Sequence IV Surveillance Panel | MINUTES

Relevant Test:	Sequence IVB
Note Taker:	Chris Mileti
Meeting Date:	04-26-2018
Comments:	The purpose of this meeting was to discuss the recent LTMS motion and its negative votes.

IVB FEWMEOOT LTMS Suggestions

Follow-Up to Lubrizol's Comments Sequence IVB LTMS Vote

Evaluate Zi Limits

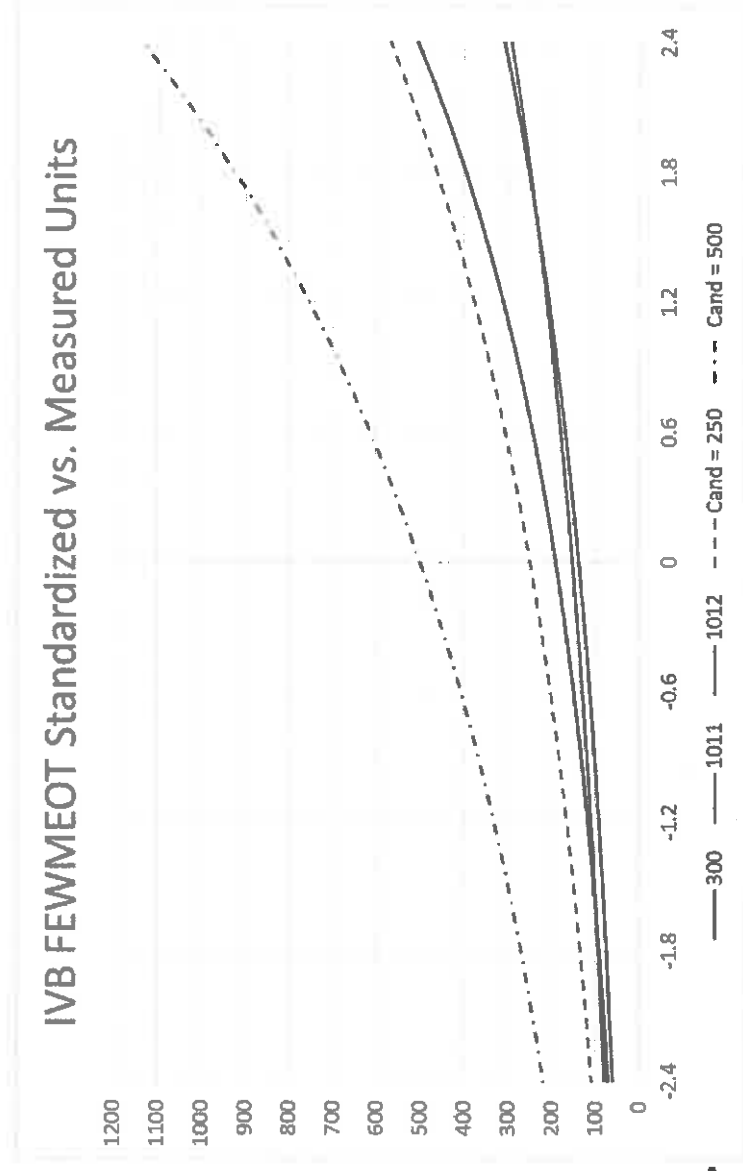
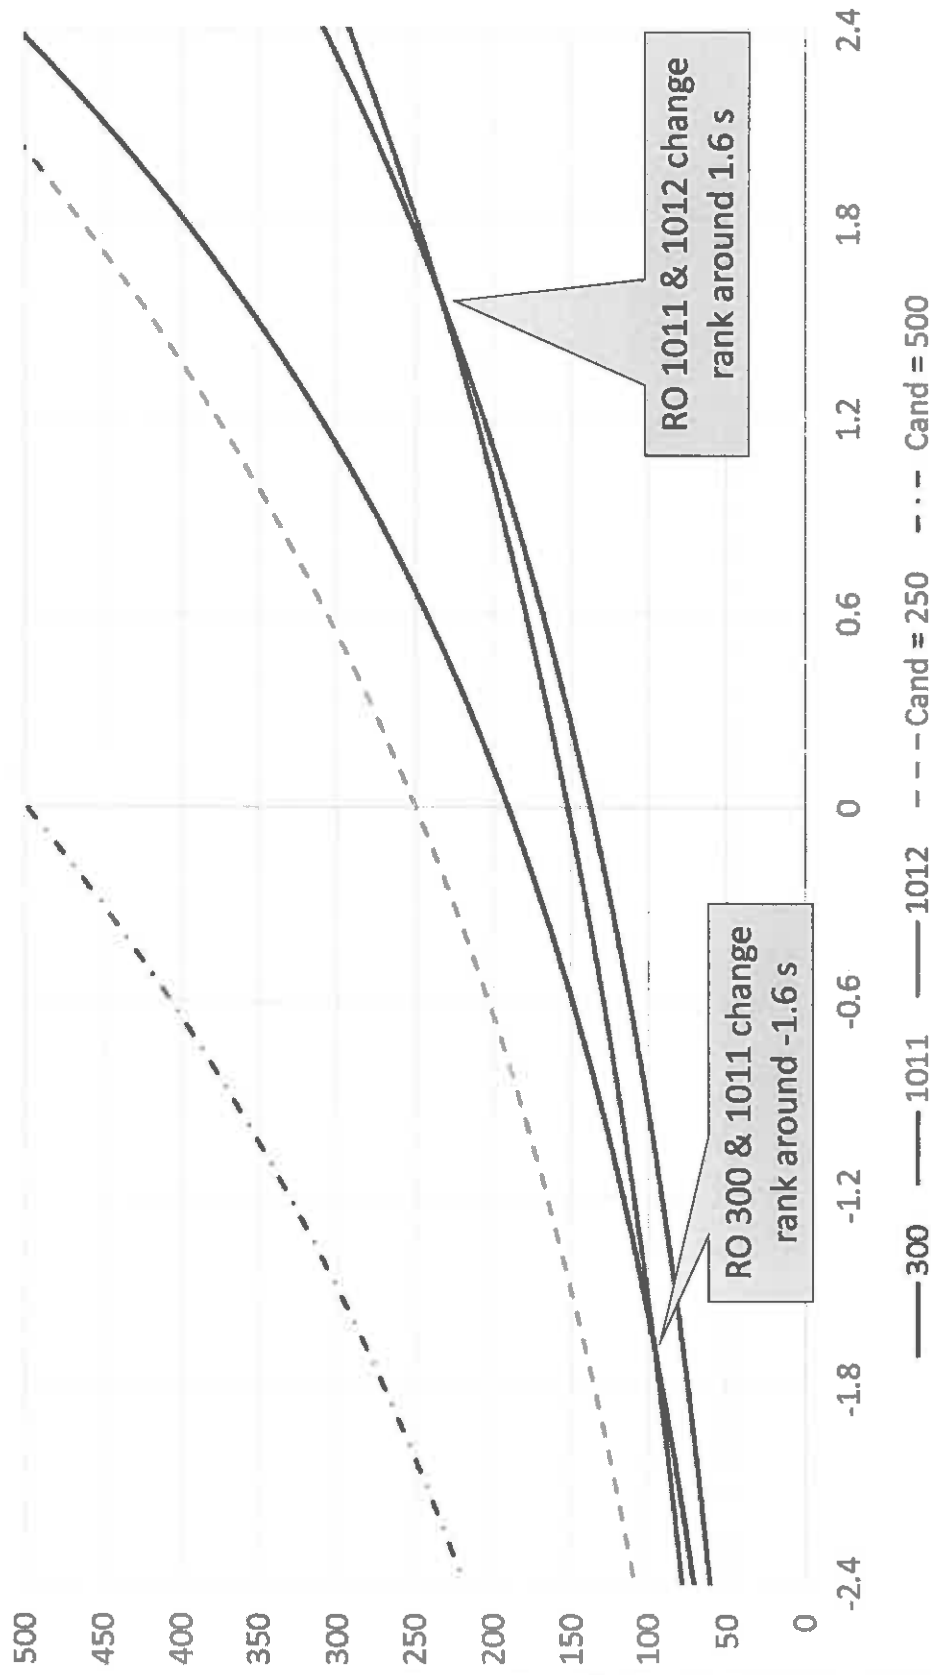
- A review of the behavior of reference oils and severity adjustments at severity extremes indicates that Zi limits wider than ± 1.8 are not advisable. This also supports the need to implement both e_i and Zi limits as the FEWMEOOT behavior at severity extremes is not understood.

- Adopt e_i and Z_i limits for FEWMEOOT reference acceptance with the Excessive Influence calculation using the limits below.
 - e_i Level 3 = ± 2.794
 - e_i Level 2 = ± 2.523 (optional)
 - e_i Level 1 = ± 2.126 (optional)
 - Z_i Level 1 = 0.000, continuous SA's
 - Z_i Level 2 = ± 1.800

Lifter Buttons – Wear (continued)

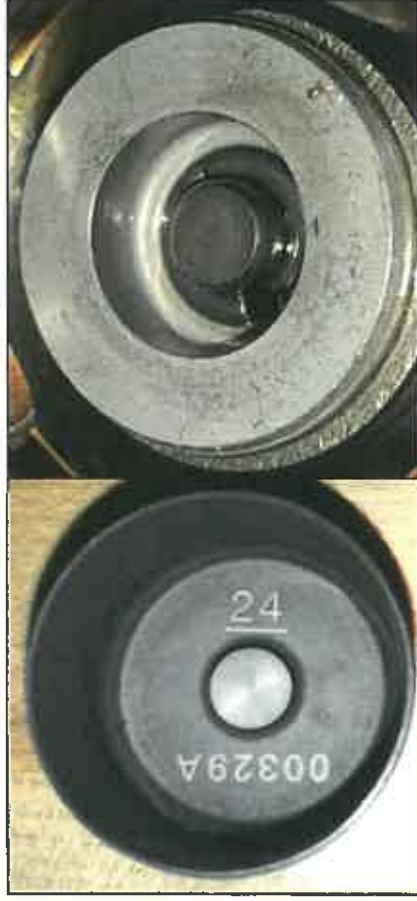
- 2.5.1. The excessively worn button had a wear volume that was almost as high as the wear volume from the lifter's upper surface (that is in contact with the camshaft).

Lifter Buttons – Wear (continued)

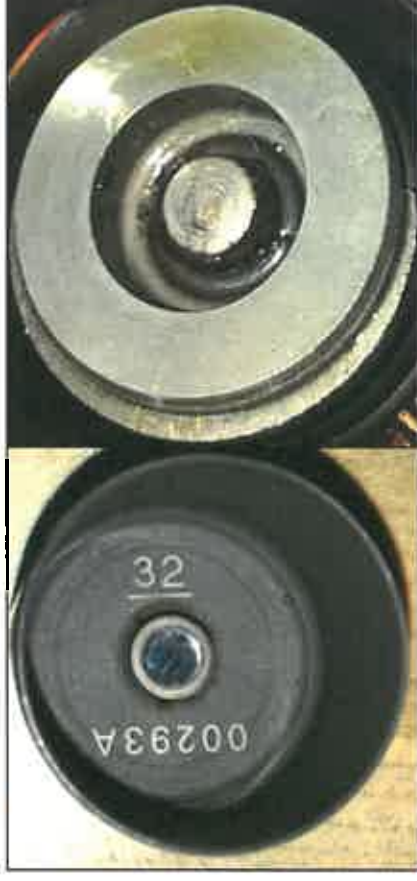
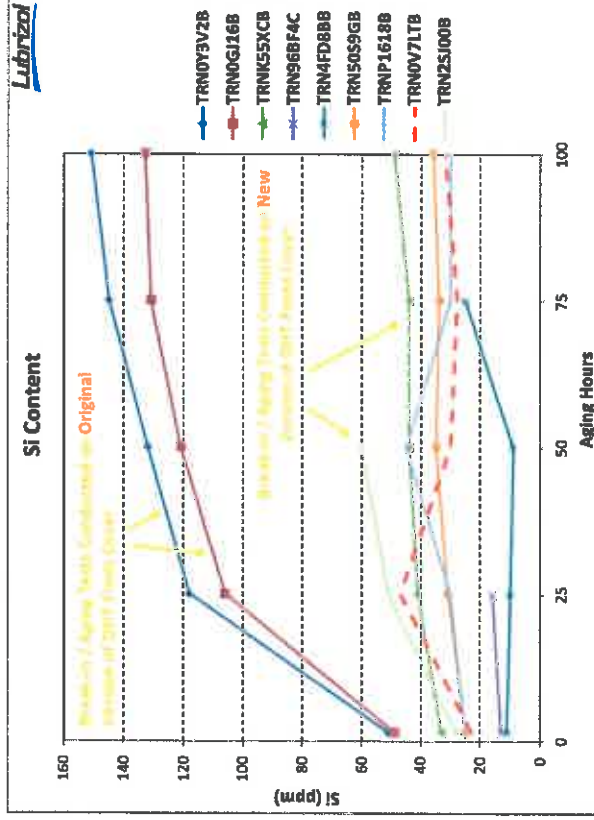
- 2.6.1. Lubrizol is confident that excessive button wear is the result of deformed valve stems.
- 2.6.2. Valves are only replaced when the cylinder head is changed.
- 2.6.3. As a result, valve stem deformation can significantly increase the iron generation of future candidate tests.

- For this test kit, lifter positions that had the most valve stem deformation also seemed to exhibit the most button wear.

Comment #2 – Break-In/Aging

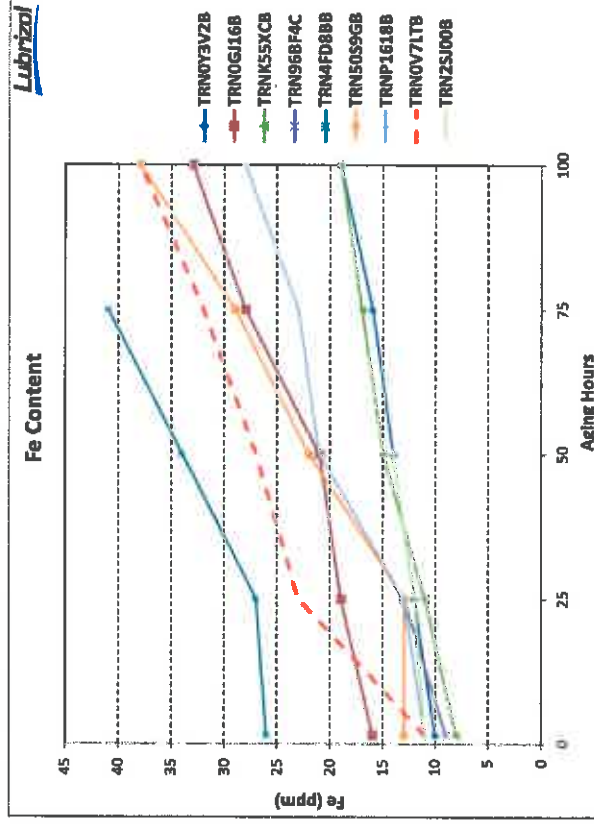
- 2.7.1. The current IVB aging cycle stabilizes silicone (left chart) but not iron (right chart).
- 2.7.2. The graph on the left shows the drastic reduction in silicone that Lubrizol encountered after switching to the latest version of the OHT front cover (that uses a rope gasket).
- 2.7.3. Lubrizol's silicone level may be lower than that of the other labs because it uses the same stock rocker arm cover for all its break-in/aging cycles.

- Silicone stabilizes during break-in/aging but iron does not.
 - So the break-in process (in terms of iron) is not complete by the time the 1st test starts.
